PROJECT:  
ADDITIONS & ALTERATIONS FOR:  
**THE MARRON RESIDENCE**

**Re: 39 Barberie Avenue—Christopher Marron  
Block 76, Lot 15  
R-2.01 Zone  
First Engineering Review**

1. Land Use Board Application.
2. Zoning denial letter, dated January 26, 2021.
3. One (1) set of Architectural Plans prepared by Minkler Architecture & Design, dated November 29, 2020, consisting of three (3) sheets.

1 FRONT ELEVATION  
SCALE: 1/4" = 1'-0"

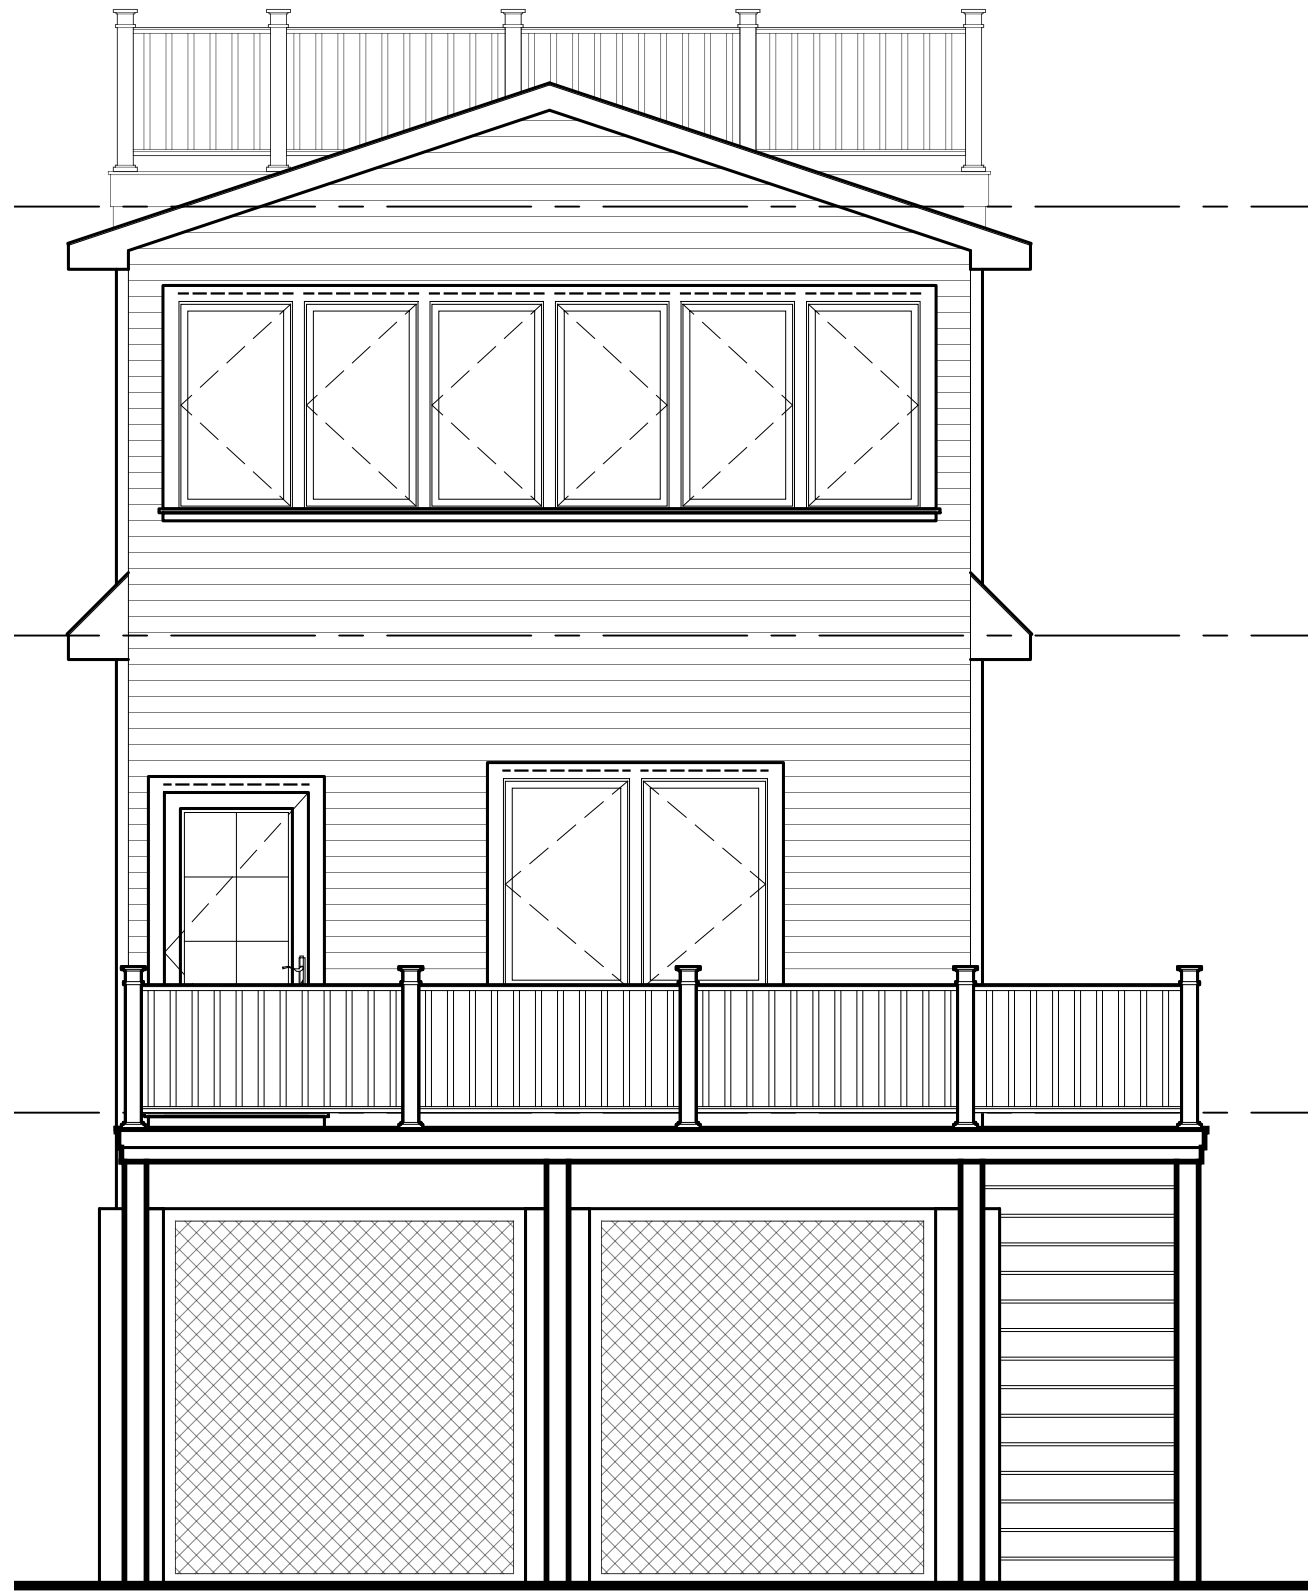
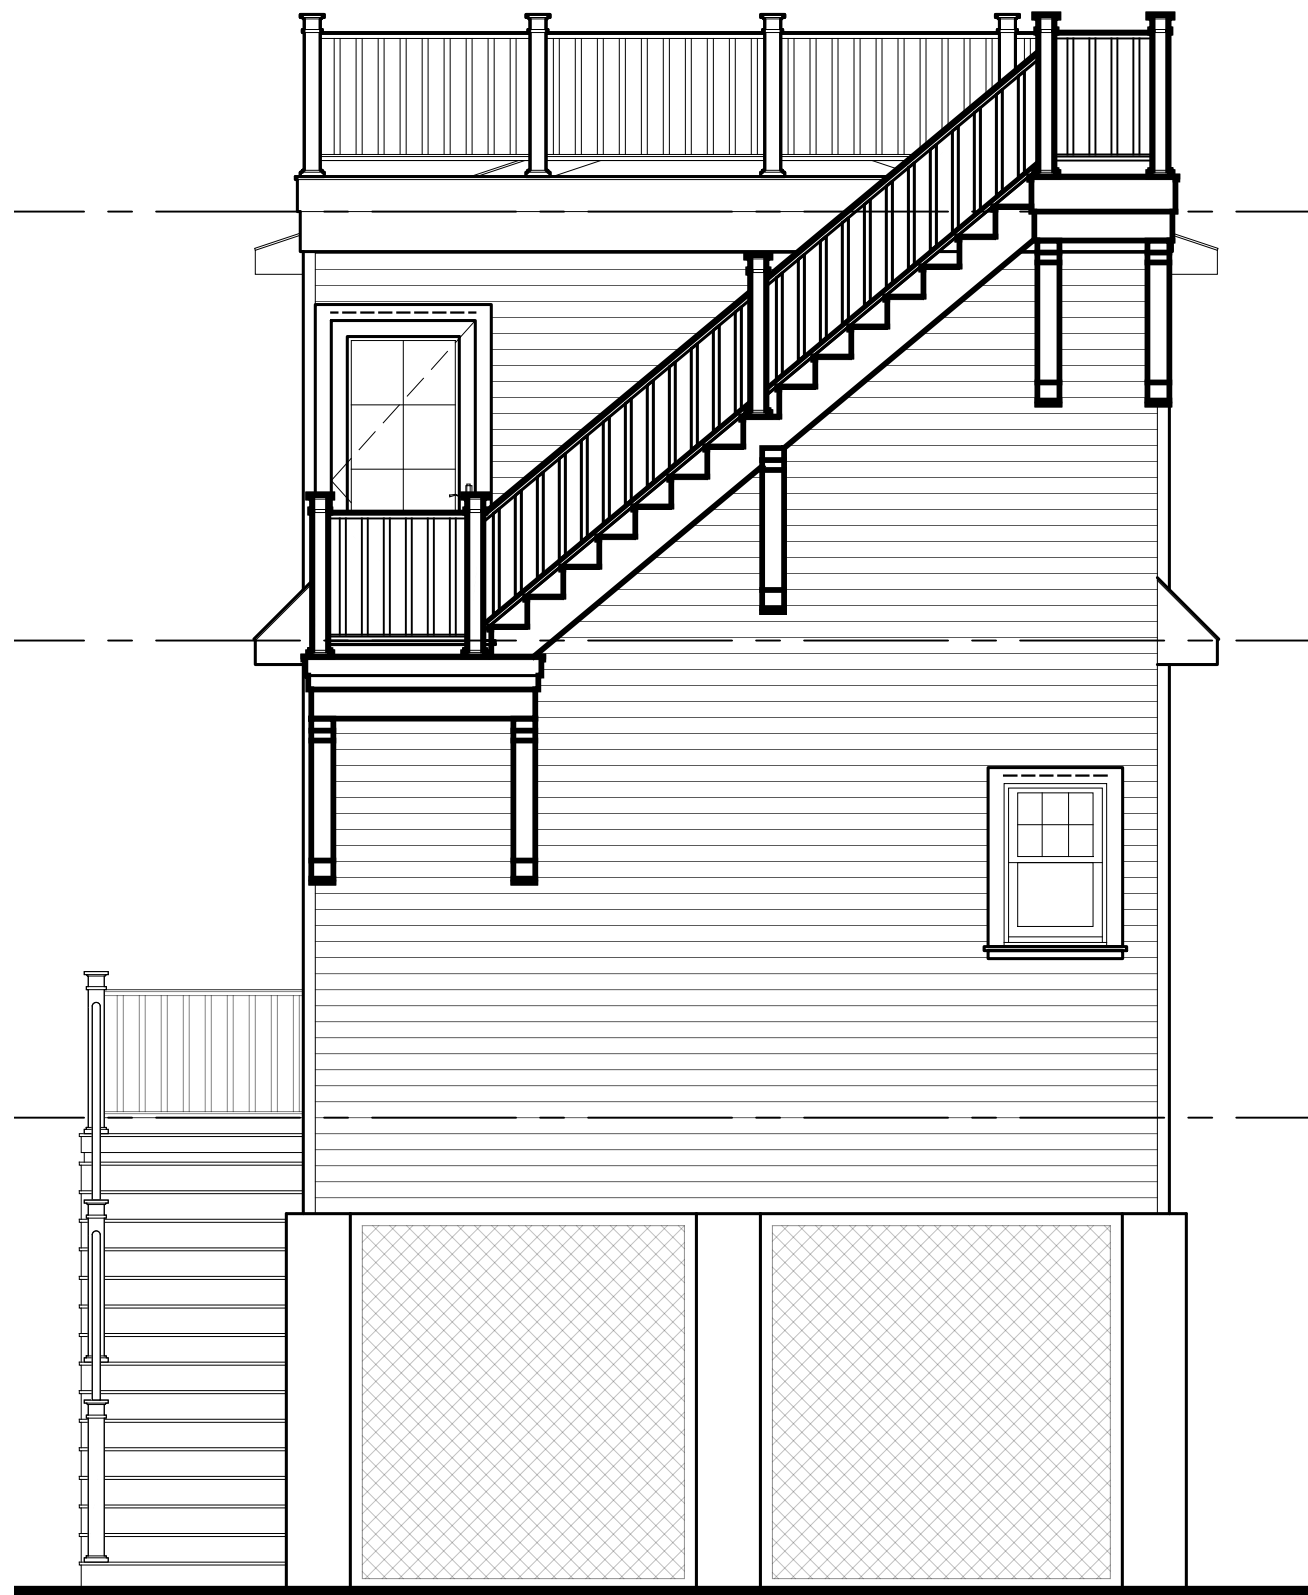
3. The property is within the AE-11 flood zone, and the plans should reflect the flood elevation on the architectural plans.
4. The building height should also be noted on the architectural elevations, with the Ordinance definition of height utilized (distance from grade plane to midline of roof).
